WEST YACHT BASIN SUBDIVISION

APPLICATION NUMBER 2 DATE August 5, 2021

REQUEST Subdivision

DETAIL SITE PLAN

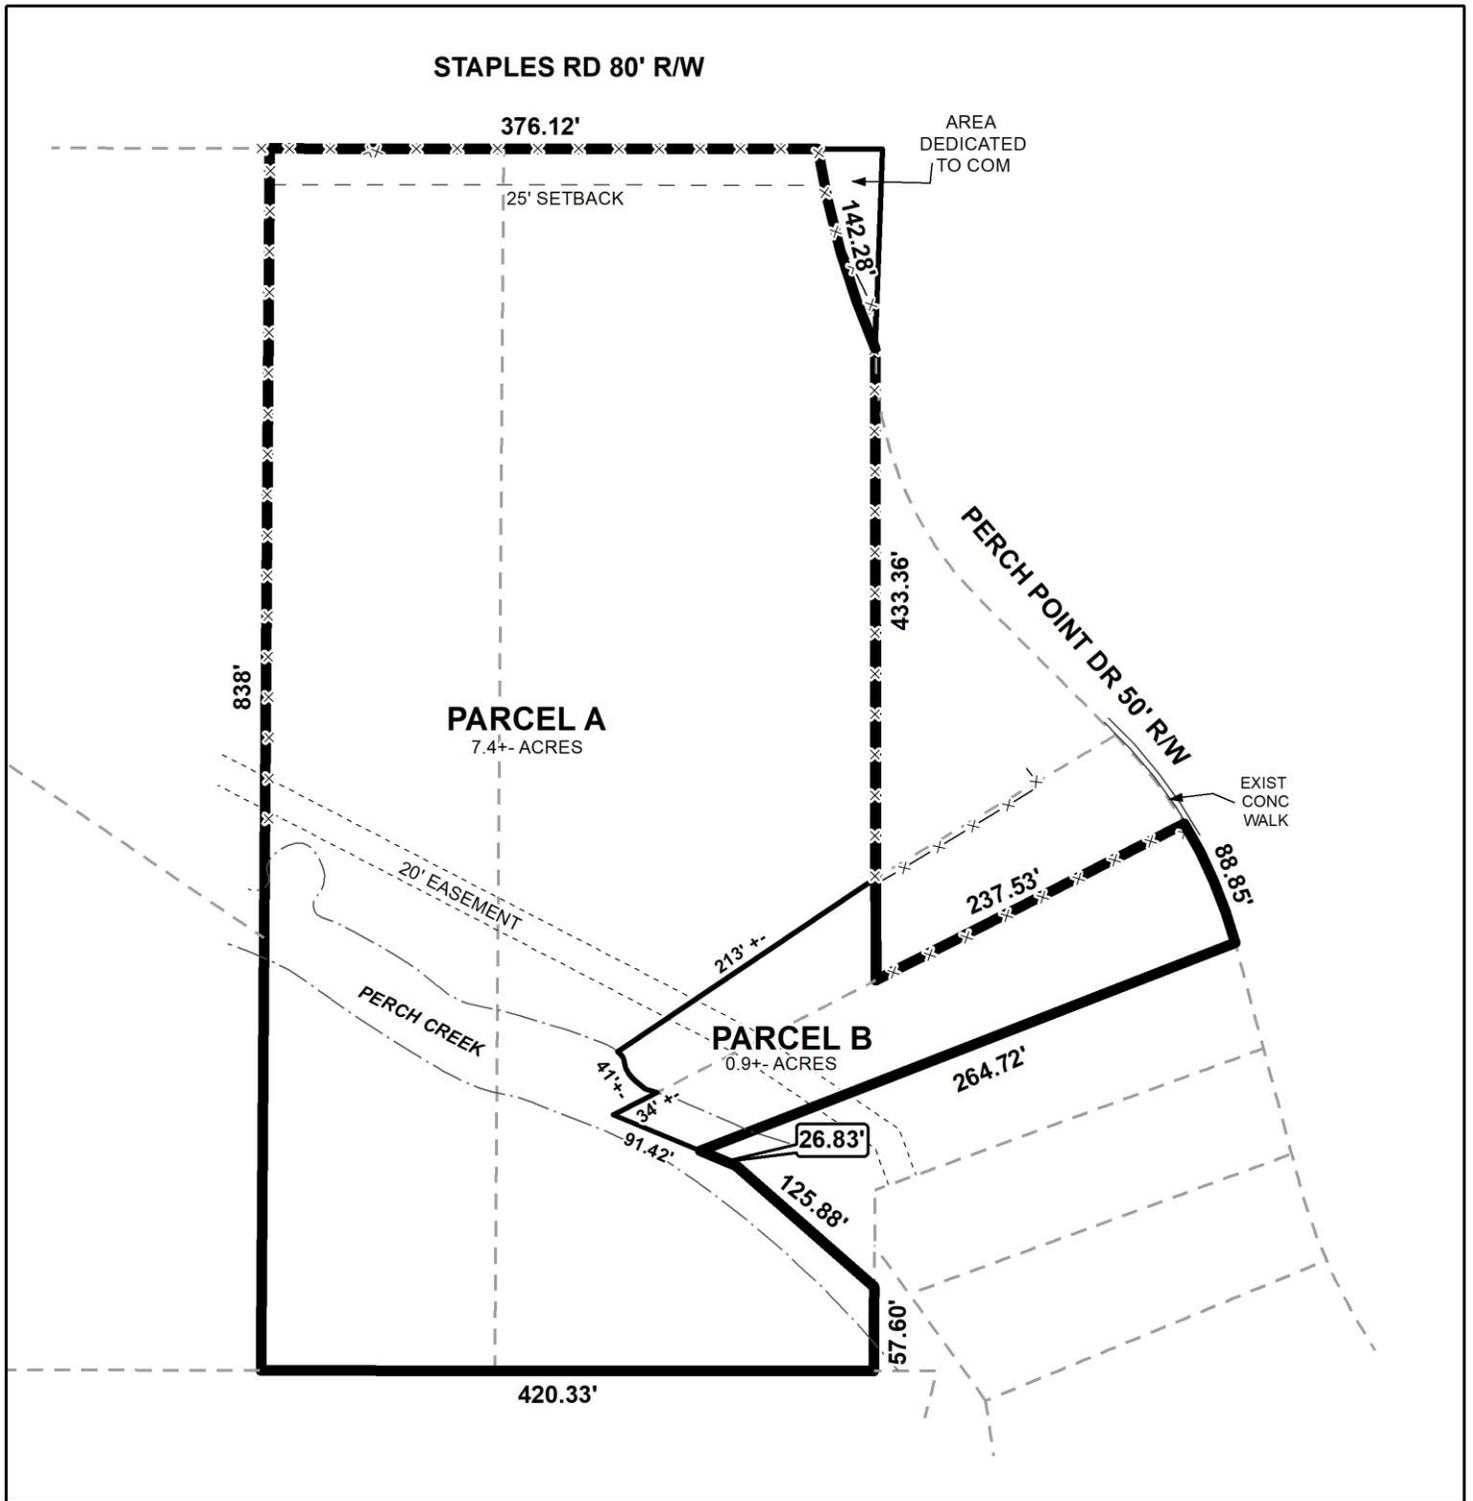
- D. Show and label all flood zones. New maps went into effect on June 5, 2020.
- E. Show and label the MFFE (Minimum Finished Floor Elevation) on each lot that contains an AE, V, or X (shaded) flood zone designation.

- F. Provide the Surveyor's and Owner's (notarized) signatures.
- G. Revise NOTE #16 to read - As shown on the 1984 aerial photo (FLIGHT 26 - #92) PARCEL A & B will receive historical credit of existing (1984) impervious area towards stormwater detention requirement per Mobile City Code, Chapter 17, Storm Water Management and Flood Control) as follows: PARCEL A – 5,700 SF and PARCEL B – NONE.

The plat indicates a 25-foot minimum building setback line along Staples Road, and this should be retained on the Final Plat. However, no minimum building setback line is indicated along Perch Point Drive. Therefore, the plat should be revised to indicate a 25-foot minimum building setback line along Perch Point Drive. The proposed lots meet the minimum size requirements of the Subdivision Regulations. As on the preliminary plat, the lot size labels in both square feet and acres should be retained on the Final Plat, or a table should be furnished on the Final Plat providing the same information.

The plat labels the proposed lots as Parcel A and Parcel B. This should be revised on the Final Plat to Lot A and Lot B. Lot B would exceed the maximum width-to-depth ratio as recommended by Section V.D.3. of the Subdivision Regulations. As that section was waived for the original approval of Perch Bend Subdivision, a subsequent waiver would seem in order.

The plat indicates a 20-foot sanitary sewer easement across the site. Therefore, a note should be required on the Final Plat stating that no structures shall be constructed or placed within any easement without permission of the easement holder.

- 1) retention of the right-of-way widths of Staples Road and Perch Point Drive on the Final Plat;
- 2) retention of the 25' minimum building setback line along Staples Road on the Final Plat;

- 3) revision of the plat to provide a 25-foot minimum building setback line along Perch Point Drive on the Final Plat;
- 4) retention of the lot size labels in both square feet and acres on the Final Plat, or the furnishing of a table on the Final Plat providing the same information;

- 5) revision of the lot labels from Parcel A and Parcel B to Lot A and Lot B;
- 6) placement of a note on the Final Plat stating that no structures shall be constructed or placed within any easement without permission of the easement holder;
